OWNER CHANGE ORDER

003

Project: 15051-Webster University Interdisciplinary
Science Building
8274 Big Bend Blvd
Webster Groves, MO 63119

SHEET P0404 - RISERS PLUMBING

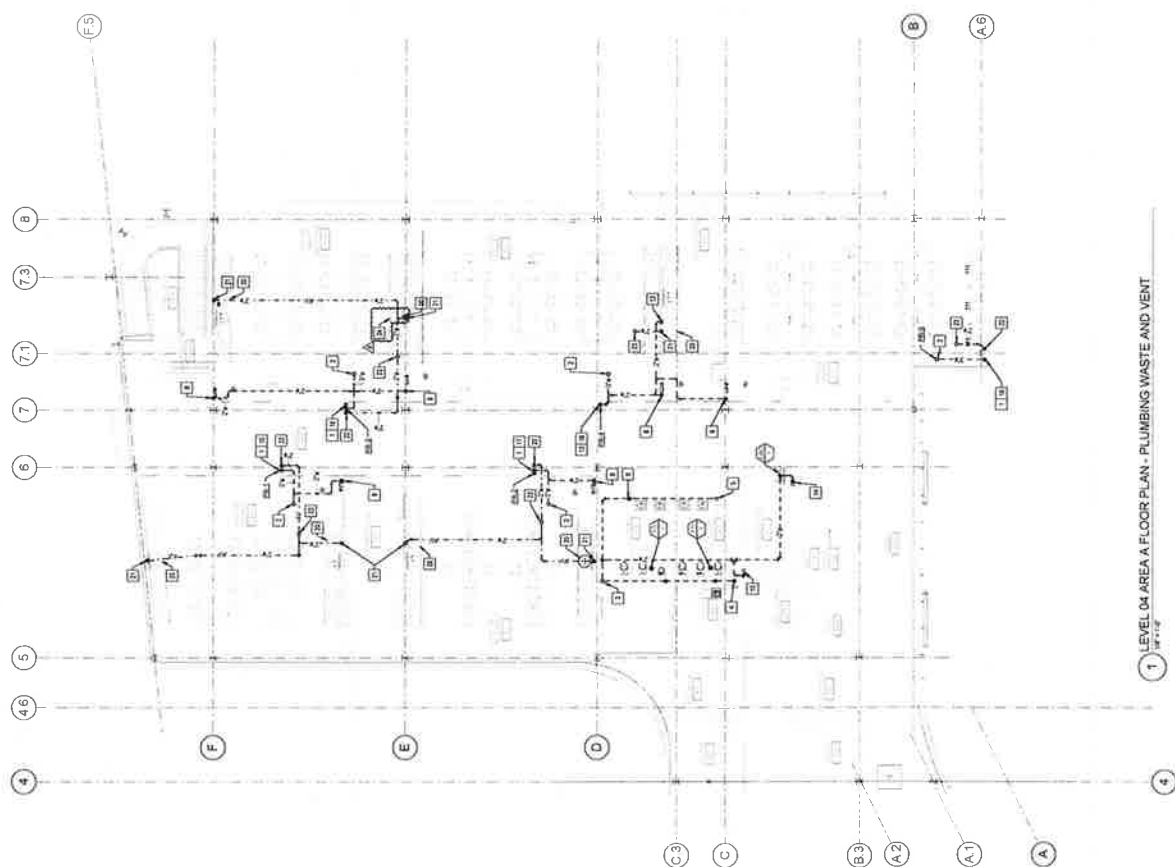
- Added riser diagram 3.

LEVEL 04 AREA A FLOOR PLAN - PLUMBING WASTE AND VENT

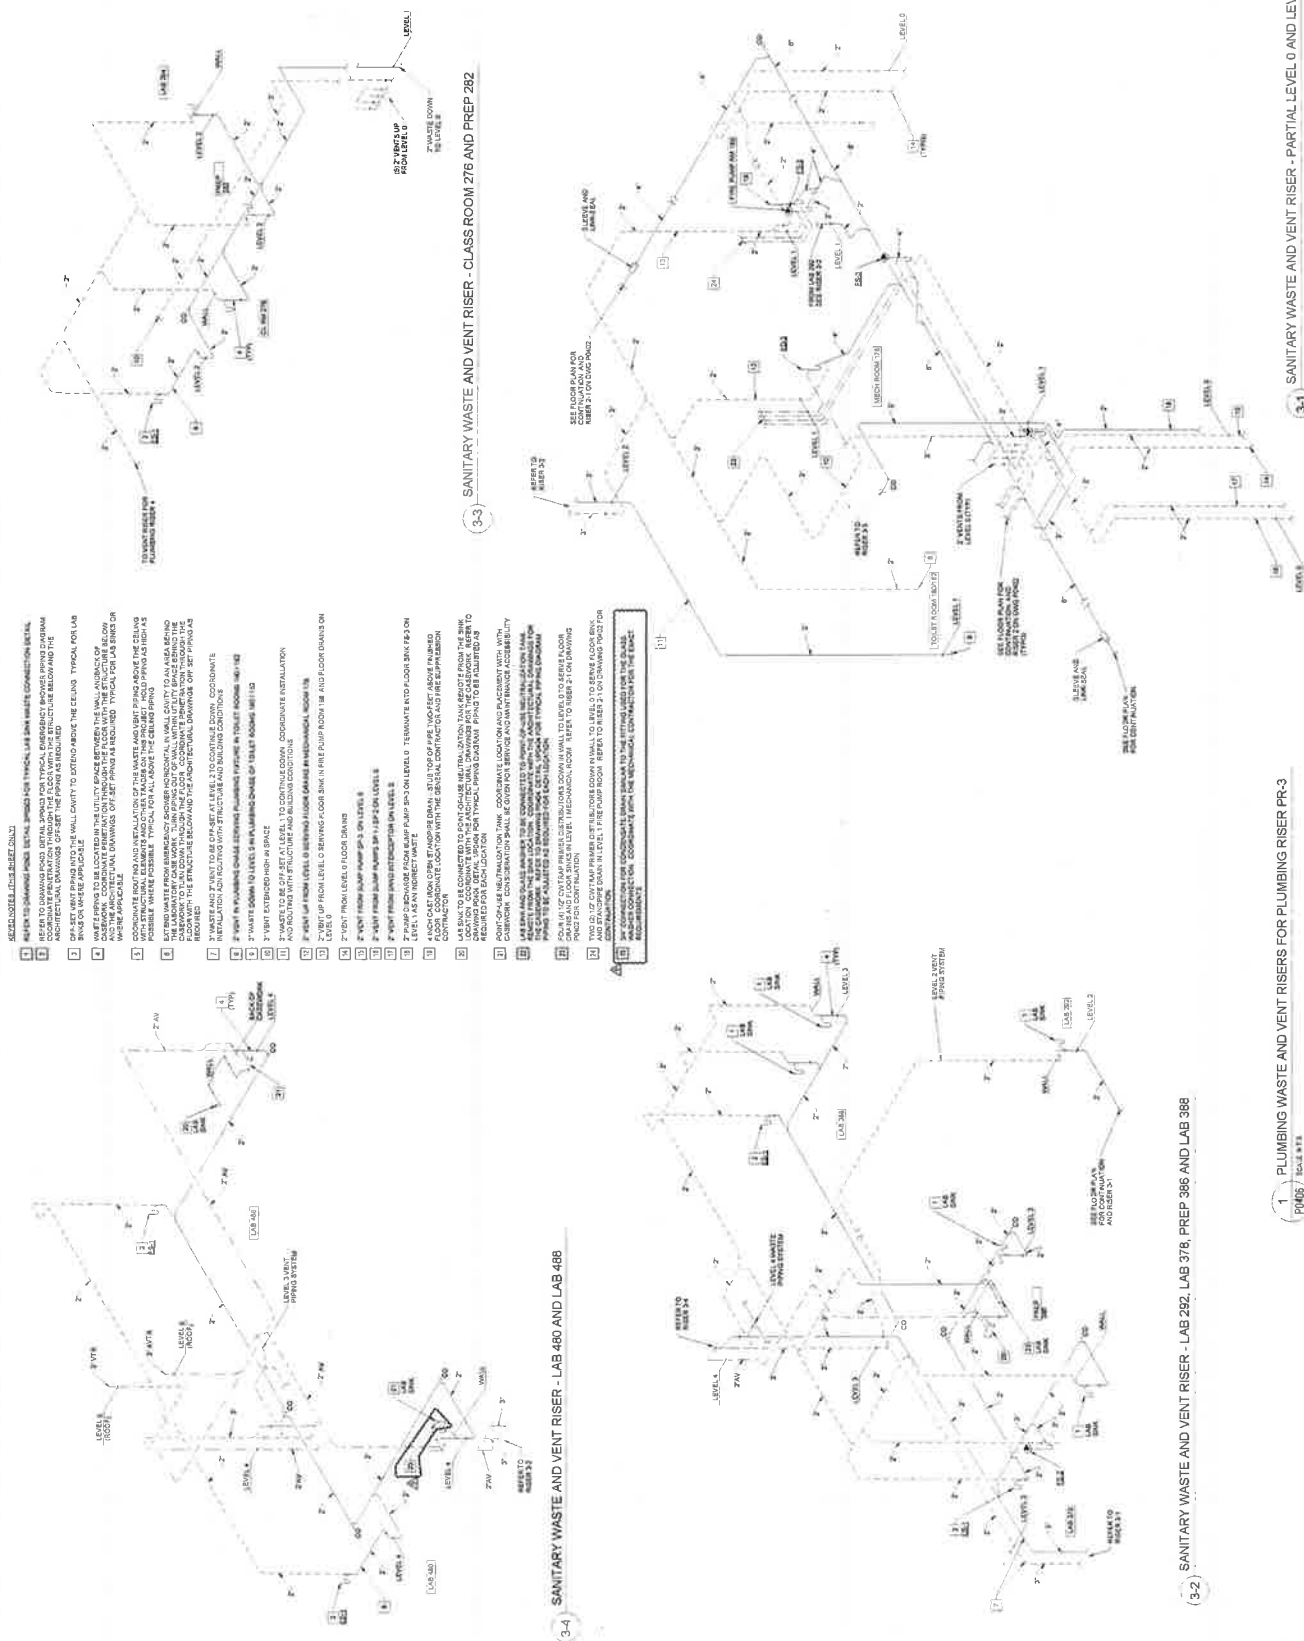
- Added key note 24 to modify waste piping in Chem. Lab – Analyt./ Inorganic 488, at lab sink along column line 'E'.

Automatic Controls equipment systems inc	Webster University / SB - HVAC Controls 270 E. Lockwood Ave. Webster Groves, MO 63119	DRAWING NAME: Level 01 24V Power Riser
	FILENAME: (2) 24V Power Riser	CONTRACT NO. WUGA-14-1 18 JAN 18 08 PM DRAWING NO.: 2.1

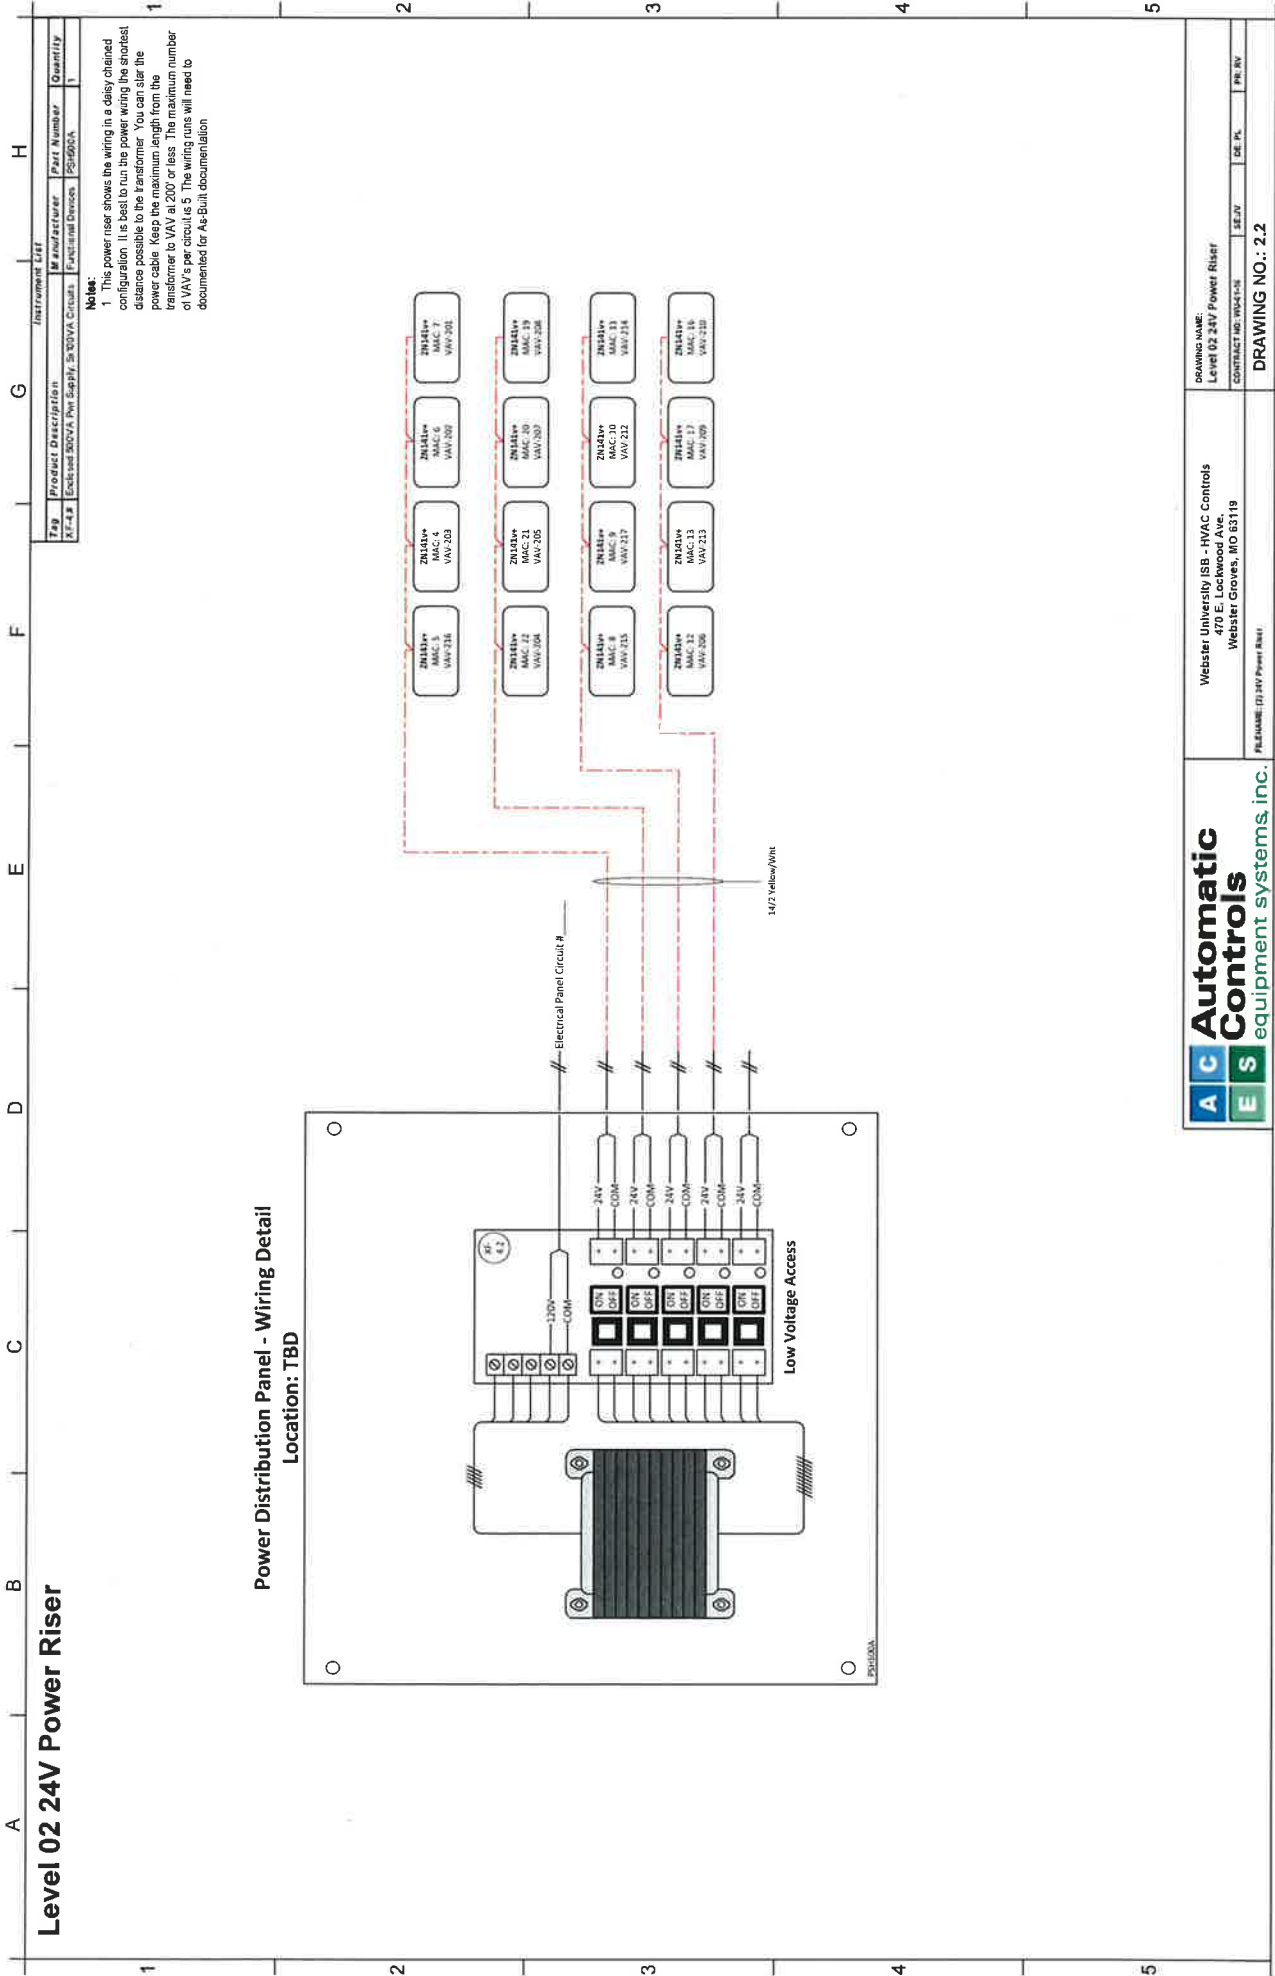
Please provide clarification for 120V power that is needed for the BMS, VAV and Phoenix power panels in the attached Temperature Controls Submittal; Drawing 1.1 and 2.1 through 2.22. Currently there is not sufficient provisions shown to power these panels.

Response: Provide emergency power for supply and exhaust Phoenix airflow control valves and associated controls serving the Cadaver Lab areas. Connect Phoenix panel serving cadaver lab, to dedicated temperature control 120 volt, 20 amp circuit, from emergency panel 1SL1.

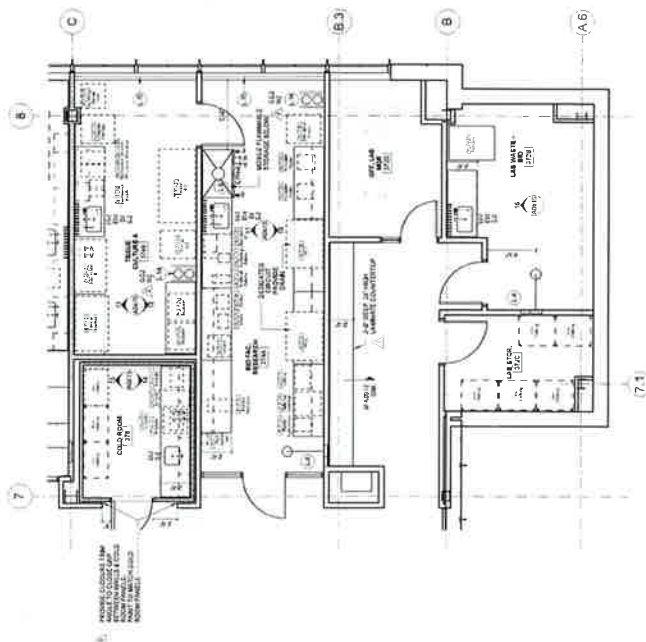
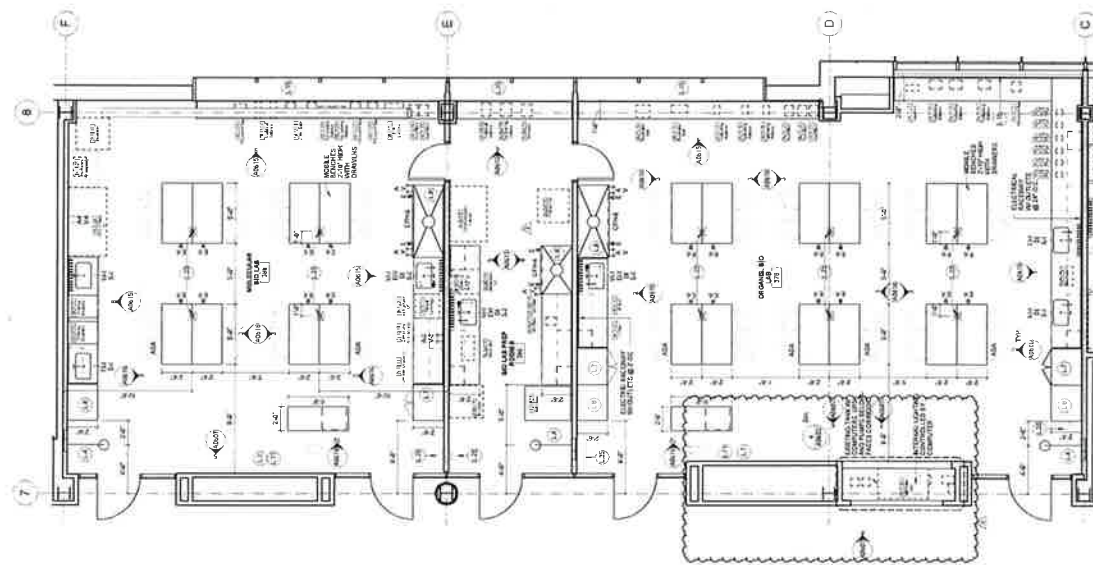
Casework revisions and Partition revisions for Aquarium in room 378.

Railings removed for west rain garden.
